1960 Corvette: Service Bulletin: Instrument Lens Cracking and Checking

Subject: Instrument Lens Cracking and Checking

Source: Chevrolet Technical Service Bulletin

Bulletin No: DR #448

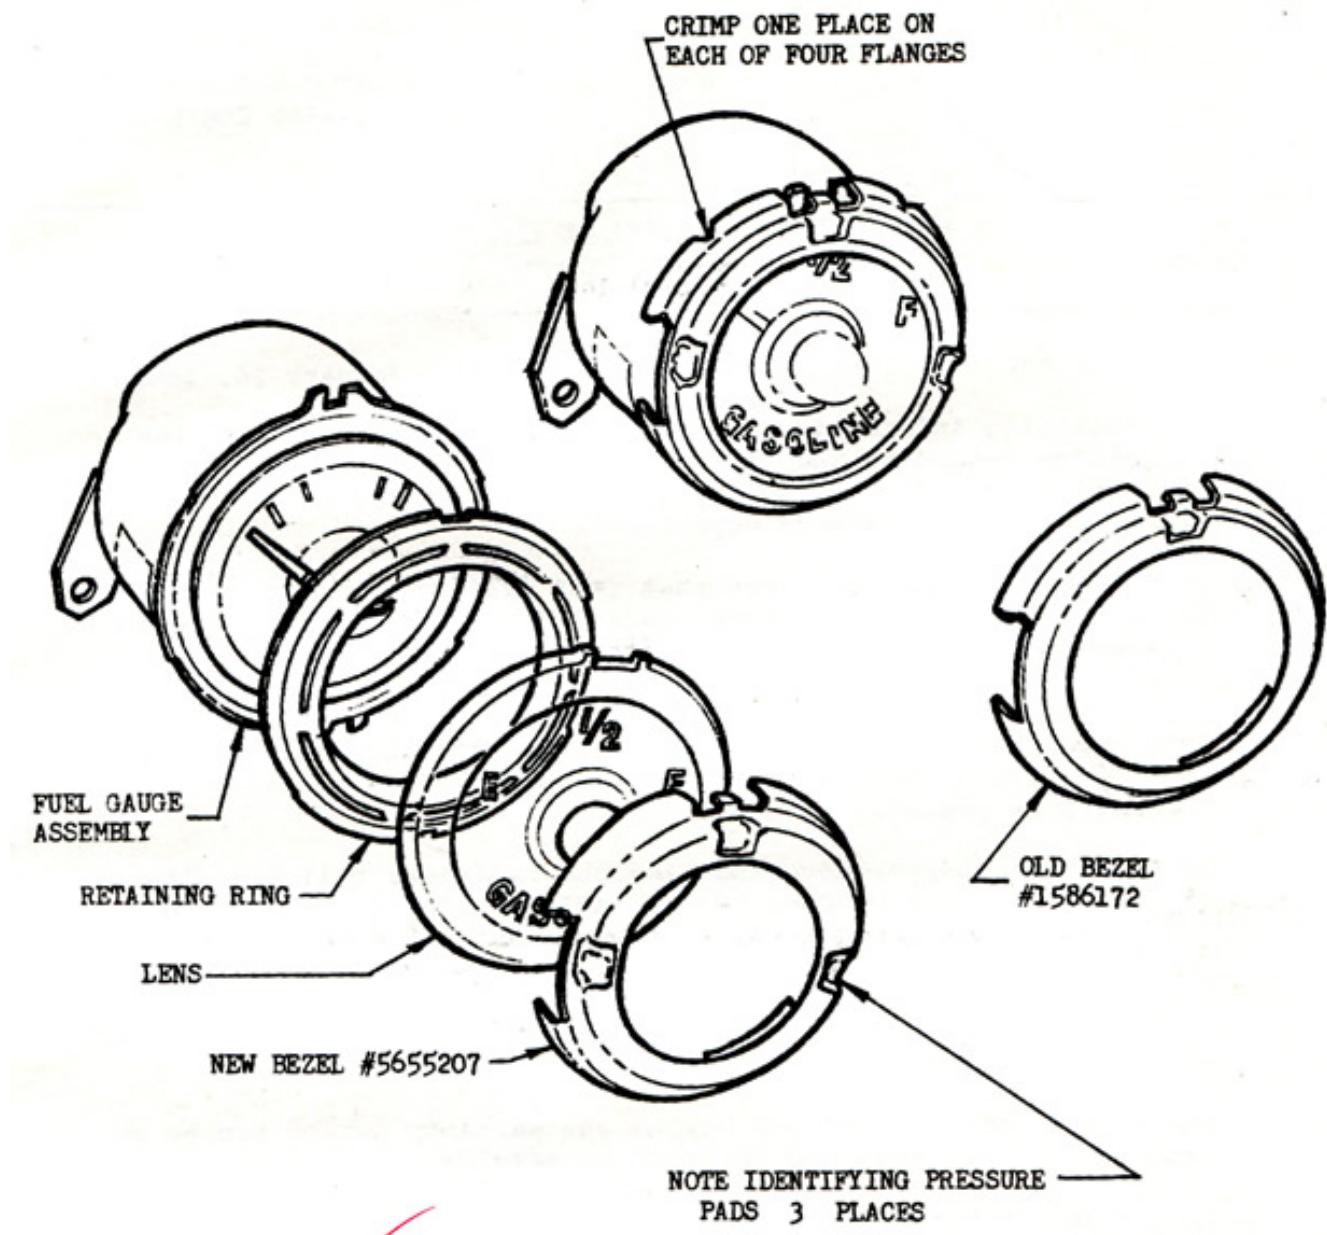
Field complaints of instrument lens cracking or checking on 1960 Passenger Cars have been traced to the means of lens retention in the various instruments.

A revised retaining bezel has been released for production and is available in Service Parts Stock. Three bezel pressure pads have been added and the number of crimps has been changed from eight to four as shown in the illustration.

When replacing a damaged lens, it will also be necessary to replace the first design bezel with the revised bezel listed below. no changes has been made to the individual fuel, temperature and tell-tale lenses.

The new bezel should be crimped in one place on each of four flanges as shown in sketch after it is positioned over the lens. When reinstalling gauge

assembly to instrument panel, tighten mounting screws a minimum amount necessary to remove looseness and rattle of the lens. Do not overtighten!
